NOTICE OF DECISION TO CONSENT TO AMEND A REFERRED PROPOSAL DURING ASSESSMENT

Murchison Hydrogen Renewables Project
Assessment No. 2339

Proposal Content Document

AMENDED DEVELOPMENT ENVELOPE

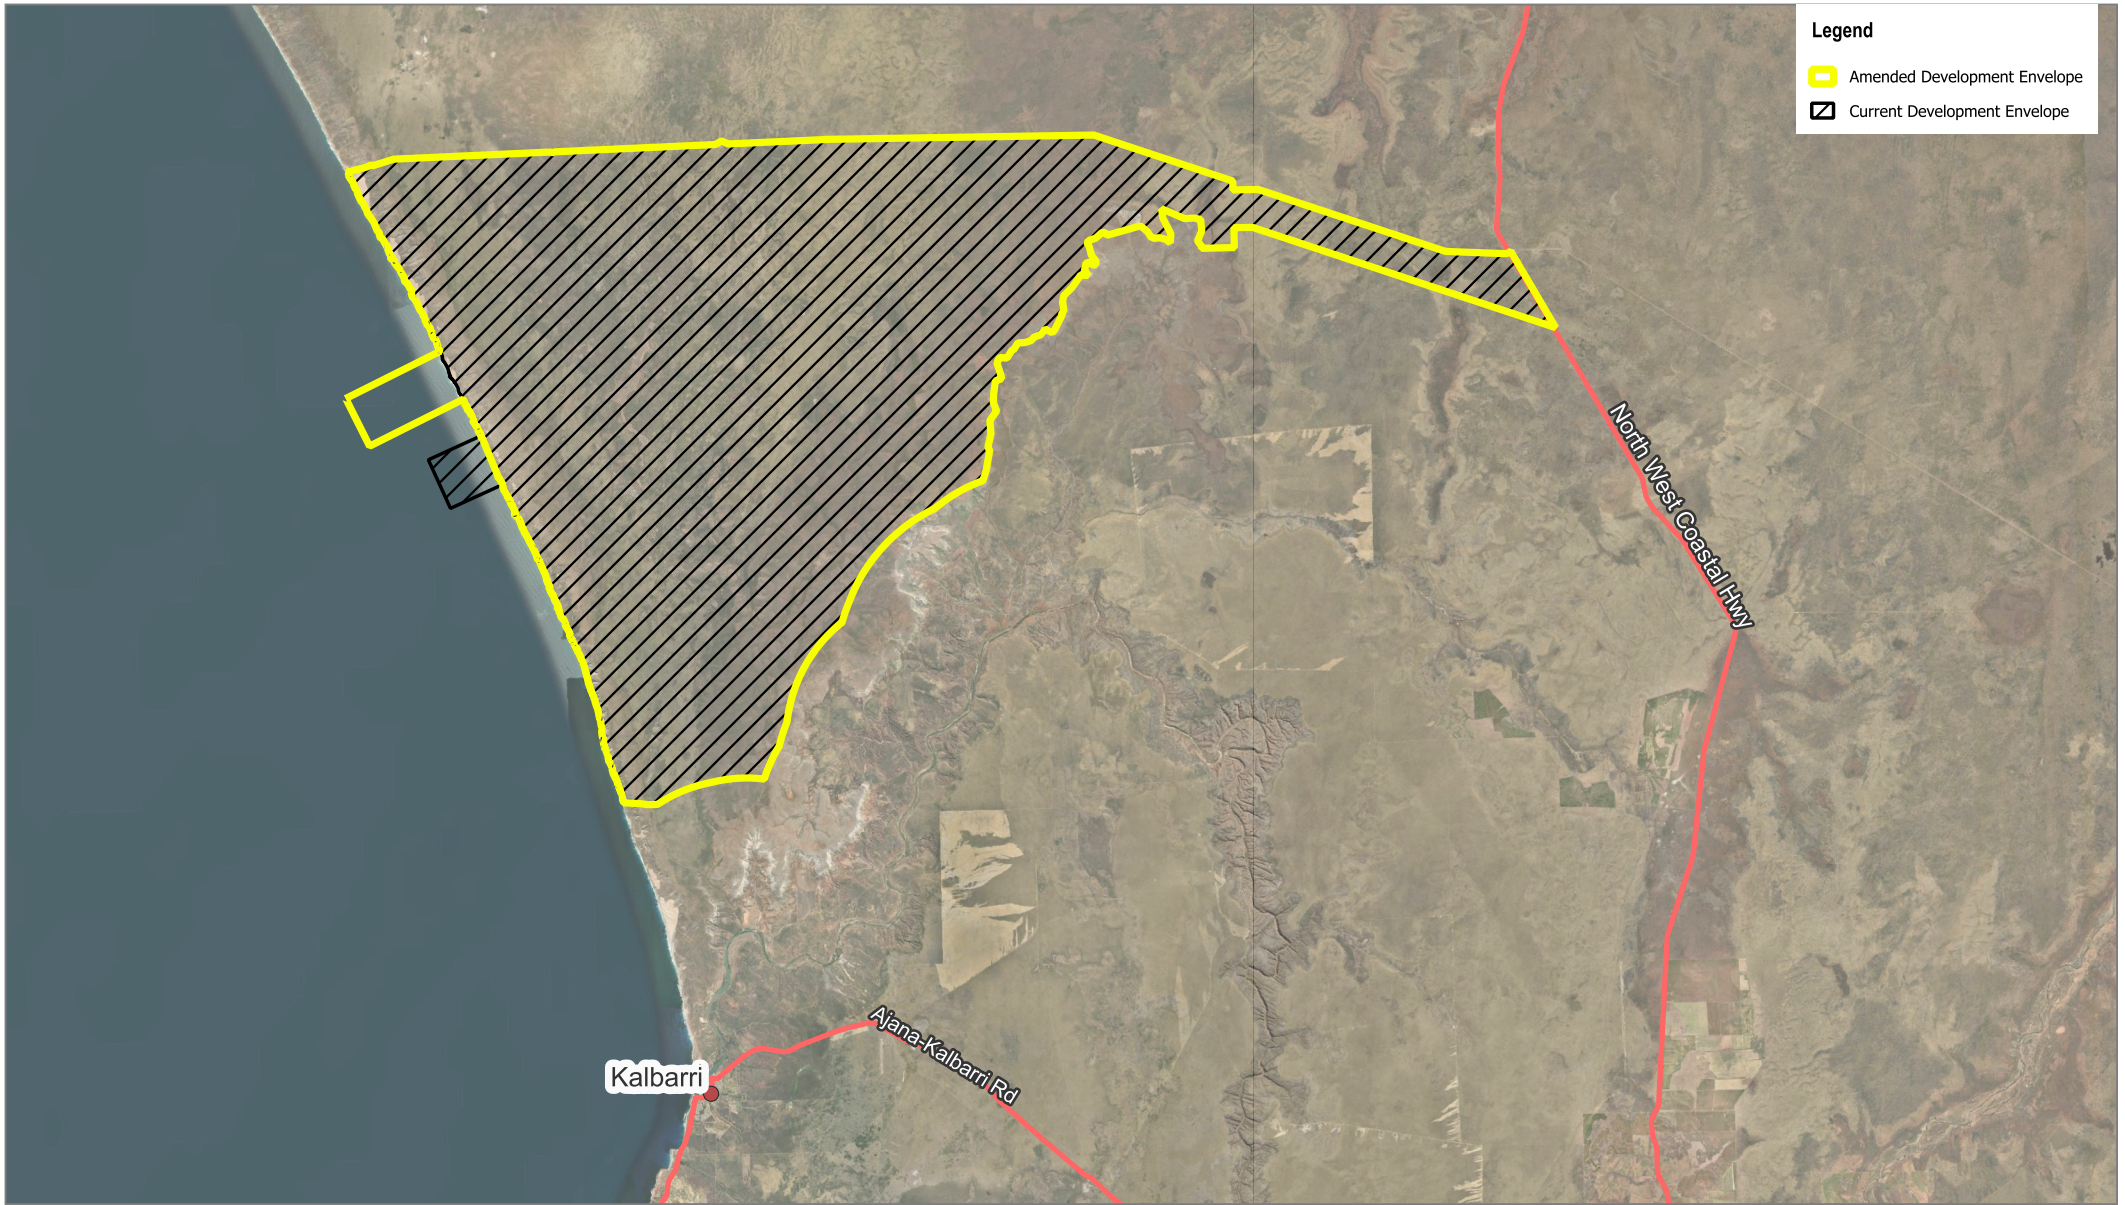
- Increase in the overall Development Envelope (DE) by 701.4 hectares (ha), from 89,555.3 ha to 90,256.7 ha. The change comprises of an increase in Marine, Power to Ammonia (PtA), and Solar Farm Areas of 699.6, 401.7 and 105.7 ha, respectively, and a reduction to the Wind Farm Area of 505.6 ha.

- Increasing the proposed DE is related to moving the proposed export facility further offshore and will likely reduce the visual impacts of the proposal. While the DE has increased, the environmental values and works required in the [approved ESD](#) remain relevant and suitable to inform the EPA's assessment.

MURCHISON GREEN HYDROGEN
AMENDED INDICATIVE SITE LAYOUT

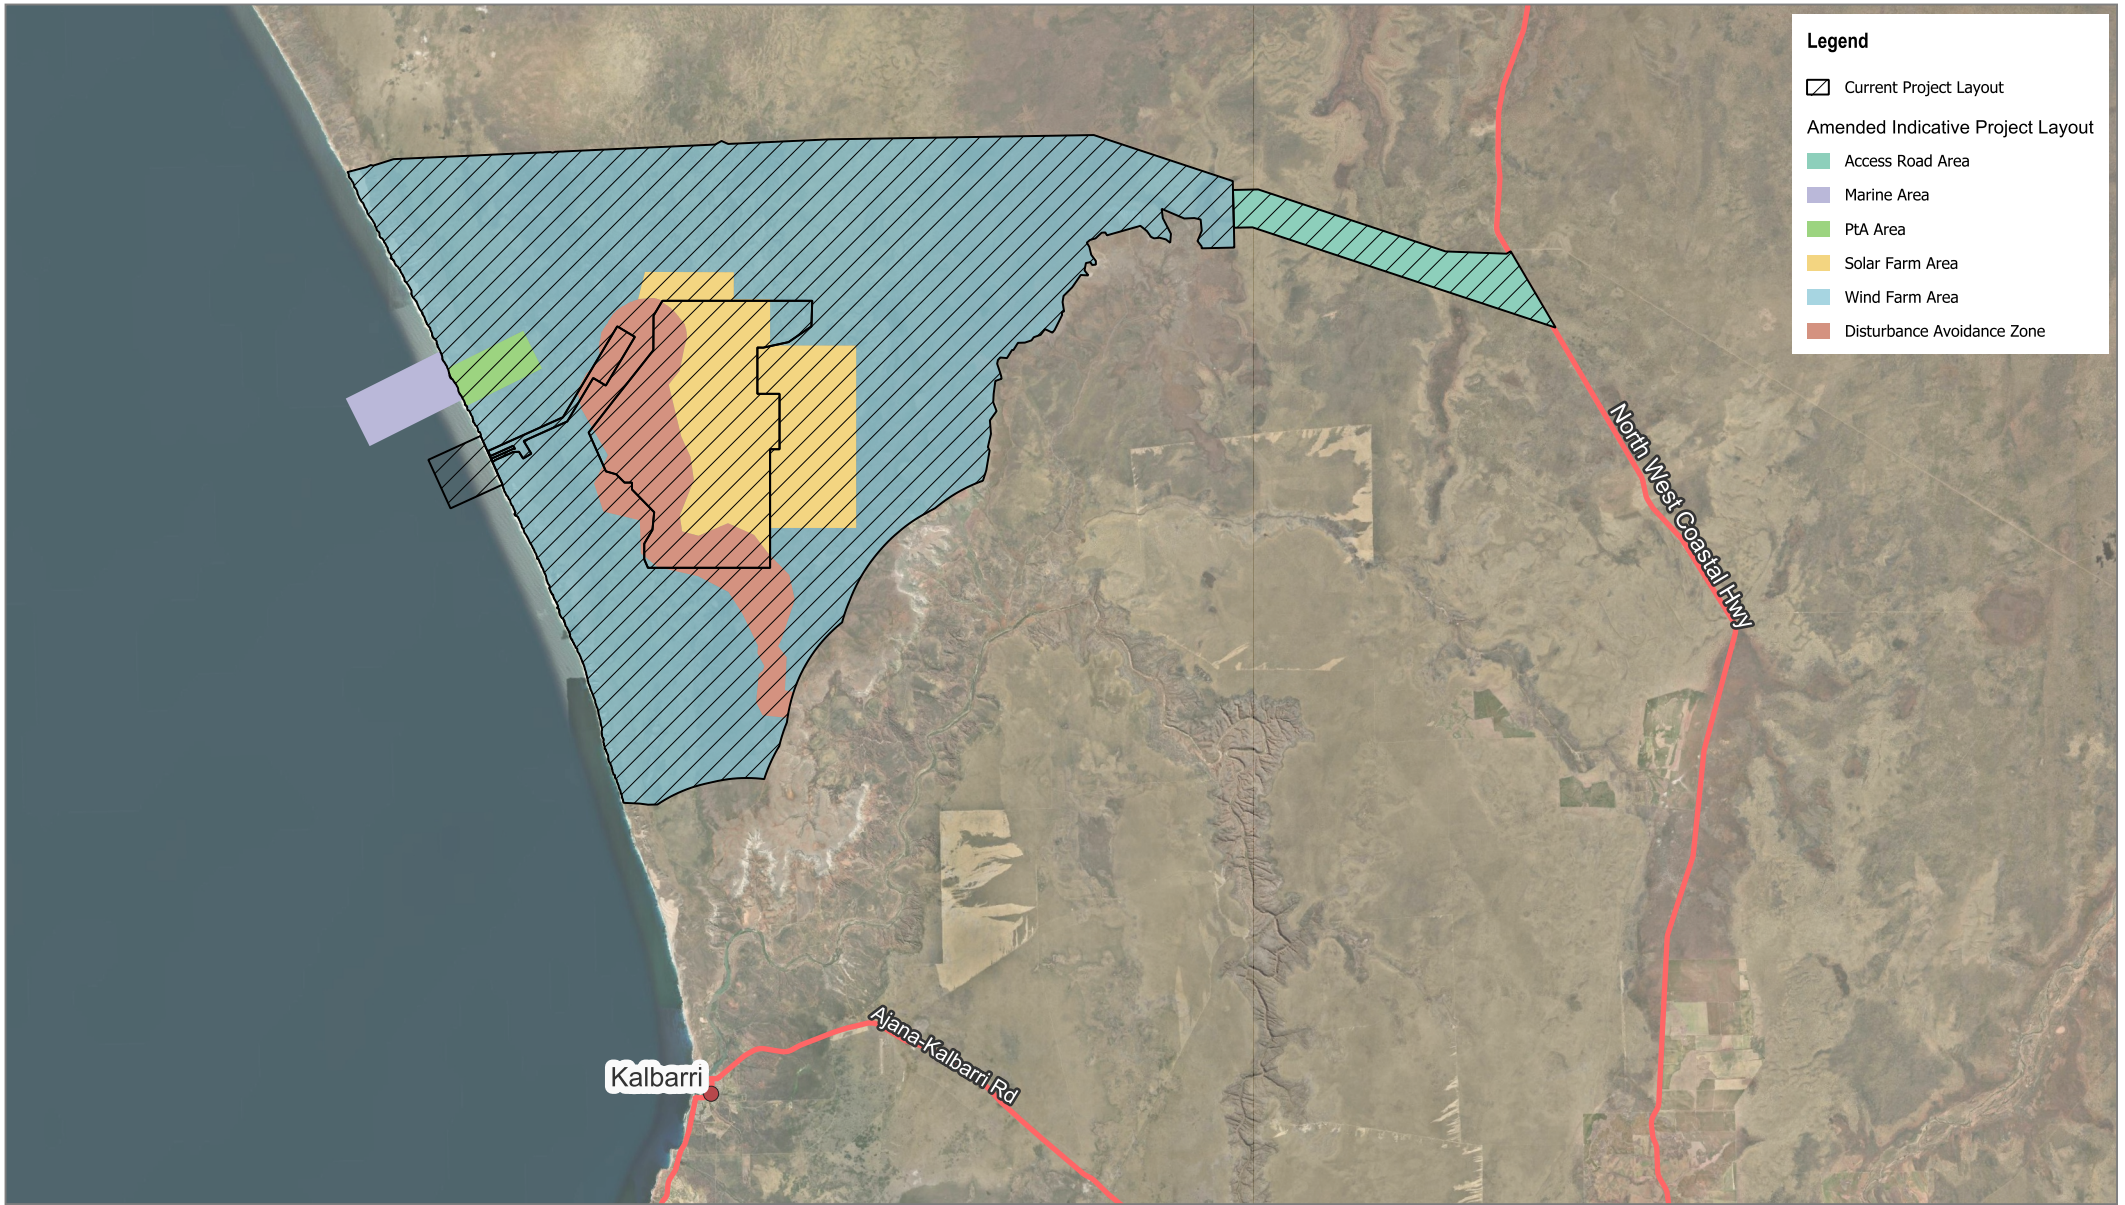
- Reduction in the permanent clearing for wind turbines by 70 ha, from 470 ha to 400 ha.
- Increase in the extent of permanent footprint of the solar farm by 200 ha, from 7,000 ha to 7,200 ha.

- Reduction in the access roads and supporting infrastructure lengths by 900 kilometres (km), from 1600 km to 700 km including an associated reduction to clearing by 200 ha, from 1,400 ha to 1,200 ha.

- Addition of up to 30 ha of permanent clearing within the DE for operational on-site accommodation
- Reduction in the onshore pipeline corridors between Main PtA plant, ammonia storage and seawater pumping station by 3,000 metres (m), from 7,000 m to 4,000 m, including an associated reduction of temporary clearing of nine ha, from 43 ha to 34 ha

- Addition of 2,150 m of pipeline partially or fully trenched on the seafloor from 850 m to 3,000 m, increasing benthic habitat disturbance of up to 6 ha, from

- Increase in the marine export facility distance offshore by 2,030 meters, from 2,600 m to 4,630 meters.
- Removal of the support craft facility from the proposal.

- Reduction in the number of wind turbines by 77, from 522 of 445 turbines and production of wind generated electricity by 0.6 gigawatt (GW) from 3.7 GW to 3.1 GW.
